***Master Plan Amendment #2017-0004***  
***Text Amendment #2017-0006***  
***CDD Concept Plan #2017-0001***  
***Development Special Use Permit #2016-0022***  
***Potomac Yard Landbay H/I East Multifamily***  
***2551 Main Line Boulevard***

**Staff Recommendation: APPROVAL WITH CONDITIONS****Staff Reviewers:**

**Master Plan Amendment #2017-0004**  
**Text Amendment #2017-0006**  
**Coordinated Development District Concept Plan #2017-0001**  
**Development Special Use Permit #2016-0022**  
**2551 Main Line Boulevard**

**Graphic A: Height-to-Setback Ratio Exhibit**

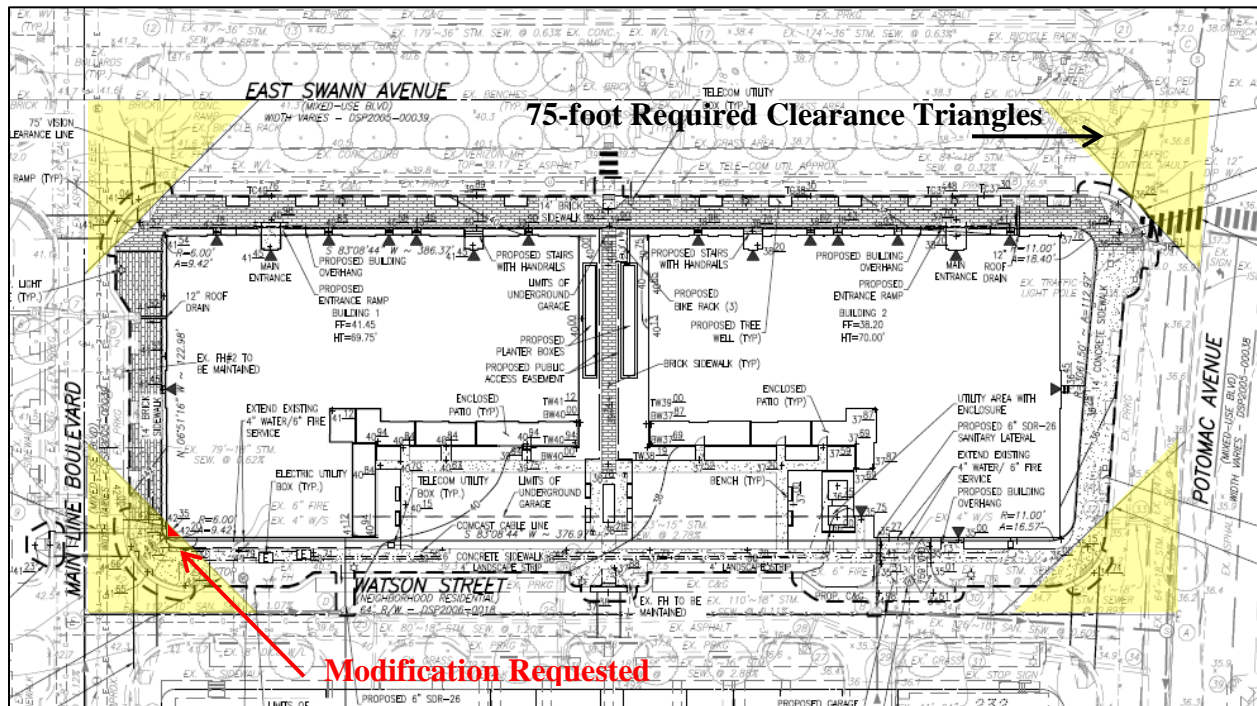
Both of the requested modifications are desirable in this instance. The modification of the vision clearance requirement is slight at only six feet less than required and would occur only at one of four intersections around the site (Main Line Boulevard and Watson Street). The height-to-setback requirement modification is also modest: in two instances it represents about five feet of additional height compared to the setback provided (or, vice versa, about 2.5 feet of reduced setbacks compared to the height provided) and in the third instance it amounts to less than one foot of additional height. In addition, it has only been requested at three of the six instances in which the requirement applies. Ultimately, staff believes the modifications are desirable given that they bring the proposed buildings closer to the street, supporting the creation of a streetwall consistent with the urban development pattern broadly recommended in the Small Area Plan. Both modifications have often been modified in Potomac Yard to create more urbane buildings.

- Specific and identified features of the site design make up for those impacts otherwise protected by the regulations for which modification is sought.

The intersection of Main Line Boulevard and Watson Street has already been constructed with curb and gutter as part of area-wide road infrastructure improvements at Potomac Yard. The parking lane on Watson Street is tucked behind the area at which a new curb ramp will be constructed, forming an area that functions as a bump-out to bring pedestrians closer to the intersection for greater visibility and safety. This design feature would mitigate any minimal impact from the

reduced vision clearance requirement. With regard to the height-to-setback requirement, the building has been designed in such a way that only relatively short portions of the building (the short end of the “L”) would need to be modified in two instances, thereby reducing the extent of the request and mitigating any negligible impact from the reduced height-to-setback ratio. Ground-level open space at the site, particularly adjacent to Watson Street, also mitigates the requested height.

**Graphic 1 – Revised Site Plan**

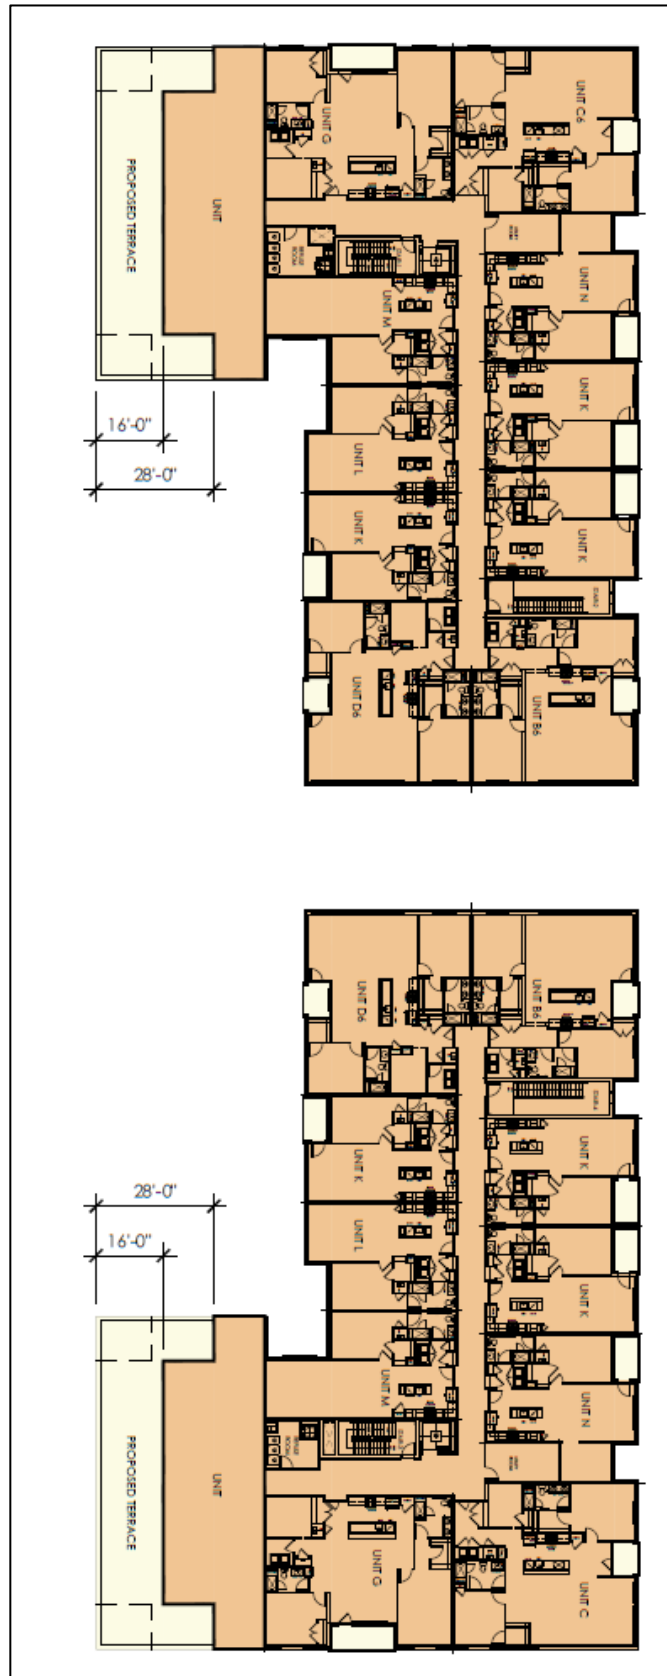
The Planning Commission agreed with the staff analysis and with the applicant's request to amend Condition #10 to incorporate the revised stepped-back design and reduction of two units from the project. A majority of the Commission believed that the proposed height and density increases were appropriate for this site close to public transportation and that the project was supportable on its merits. The Commission also discussed concerns about the community outreach efforts and specifically HOA matters. Commissioner Brown stated that there was little to oppose about the project but sought to further ameliorate impacts by decreasing the number of units and the apparent height of the buildings through an additional "step-back" on the fifth and sixth floors of the buildings.

September 20<sup>th</sup> meeting. The first of the recommendations was to increase the apparent height of the first floor as it felt out of proportion with the rest of the building. The architect achieved this change by increasing vertically the amount of the rusticated beige brick up to the window sill of the second floor which visually creates a stronger base. Similarly the Committee recommended that the apparent height of the top floor be reduced as it appeared too tall and out of proportion with the rest of the building. Again the architect was able to do this by increasing the vertical dimension of the fifth floor cornice and frieze. Finally, PYDAC members also agreed with staff to create a stronger sense of entry. This was achieved by creating a vertical band framing the entry and extending it through to the top floor. This made a significant difference and provided the added benefit of creating additional visual interest to the Swann Avenue facades.

PYDAC recommended supporting this project, including the step back revisions planned at the sixth floor. A letter of recommendation from PYDAC is attached as *Attachment #8*.

10. **CONDITION AMENDED BY PLANNING COMMISSION:** The building design, including the quality of materials and final detailing, shall be consistent with the elevations dated July 10, 2017 as amended by Exhibit A dated September 20, 2017 consisting of five pages<sup>1</sup>, and all approved conditions. (P&Z) (PC)
